SUBDIVISION REVIEW SHEET

CASE NO.: C8-2022-0007.0A

SUBDIVISION NAME: Replat of Lot 2, Drew Lane Addition

CITY OF AUSTIN –DEVELOPMENT SERVICES DEPARTMENT SUBDIVISION APPLICATION – MASTER COMMENT REPORT

REPLAT OF LOT 2,
DREW LANE ADDITION

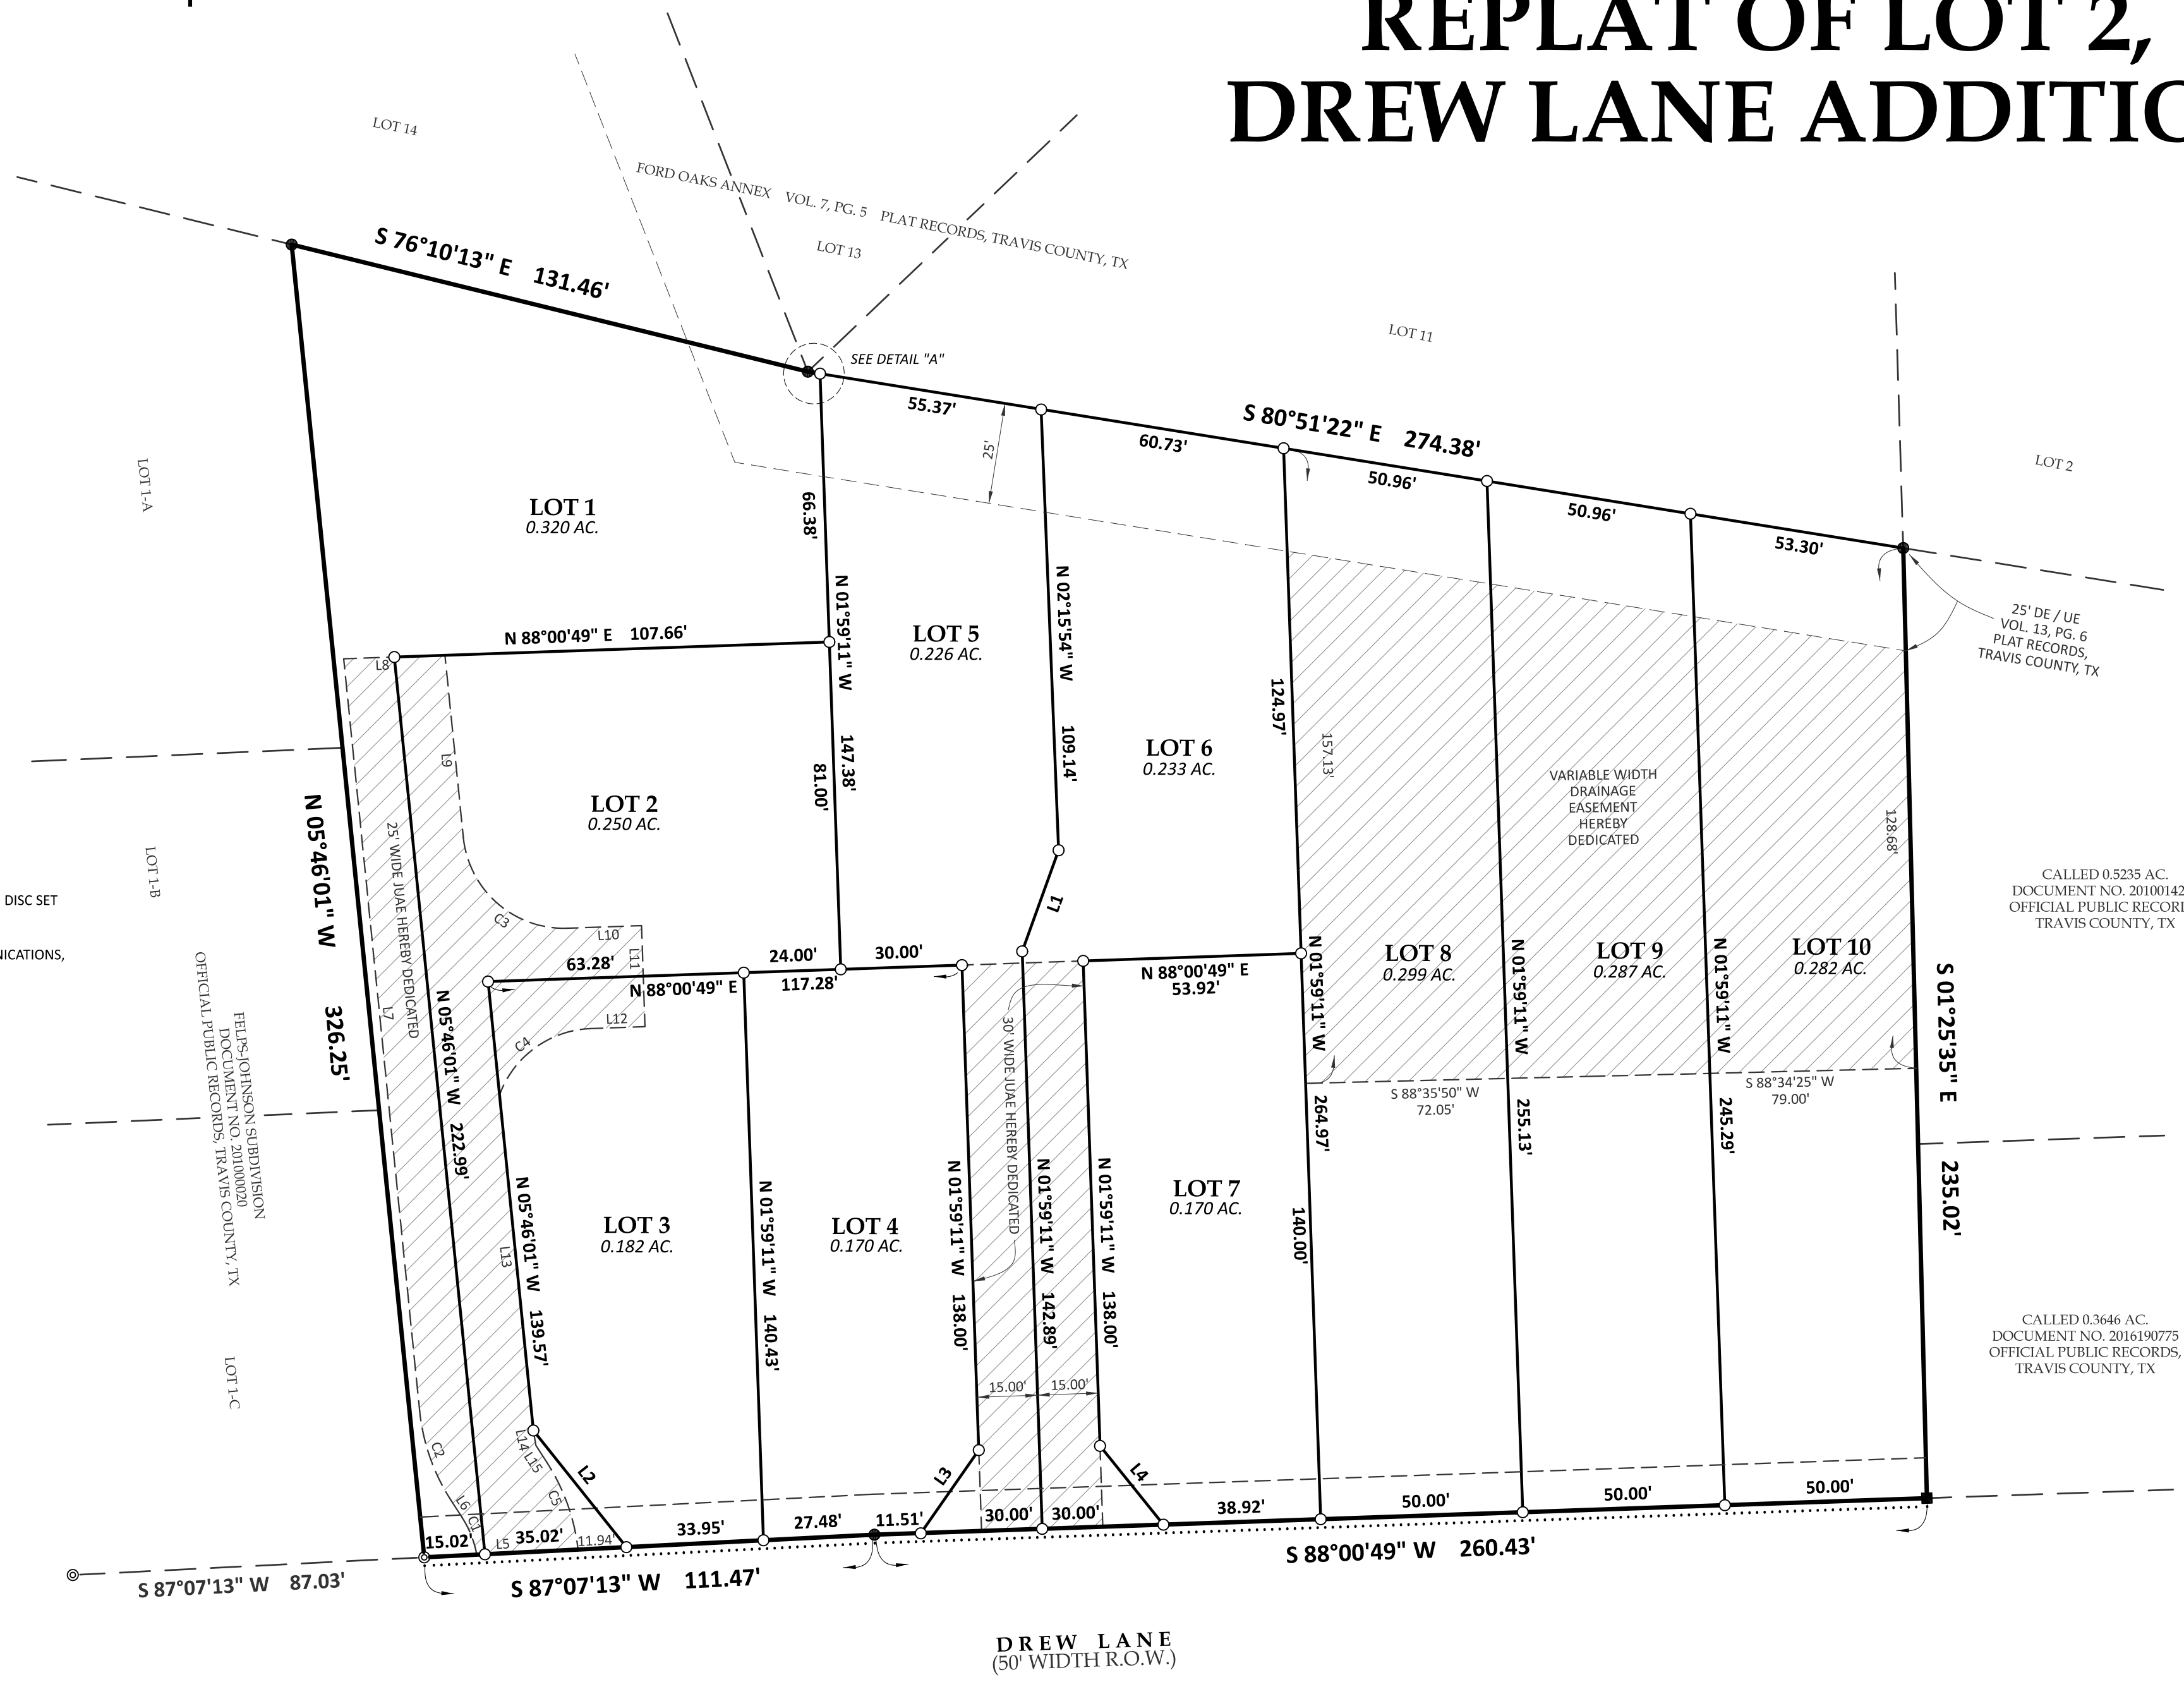
- ATD3.** The ASMP requires 58 feet of right-of-way for Drew Lane. Dedicate 29 feet of right-of-way from the existing centerline in accordance with the ASMP (LDC 25-6-55).

- ATD6.** Maximum number of driveways permitted on a street with 300-600 feet frontage is 2. TCM Table 7-4. *Please revise the 5 driveway approaches on Drew Lane.*

- ATD7.** All residential subdivisions utilizing a flag lot design must submit a driveway plan for review and approval by the transportation reviewer with the final plat application. LDC 25-4-175. Please show and dimension the driveway width and curb return radii, show and dimension adjacent driveways, and show and label the proposed single family residential dwelling units. Additional notes will need to be added to the plat per LDC 25-6-451; TCM, 5.3.1.H once the driveway profile plan has been submitted. A final driveway profile plan PDF shall be provided to the transportation reviewer prior to approval. Once the driveway profile plan has been approved by all necessary staff, provide the plan as a PDF to the reviewer (dari.majd@austintexas.gov). The final plan is required prior to approval. *Attach the PDF to the folder in AMANDA for future review staff (mainly Residential Staff).*

FP 1: The drainage easement on the plat is shown but it does not appear to contain the floodplain shown in Exhibit B of the engineering report. Please clarify.

SR2. Revise Case # to C8-2022-0007.0A in the bottom right-hand corner of each sheet. 25-1-83

SR5. Revise plat note 6, which is required by LDC 25-4-83:

SR6. There is a new county clerk starting soon please revise the name in the county recordation block to “Dyana Limon-Mercado” (25-1-83)

SR10. It looks like there is a different deed number stated in the plat than uploaded with the application? Please clarify and update if needed (25-1-83)
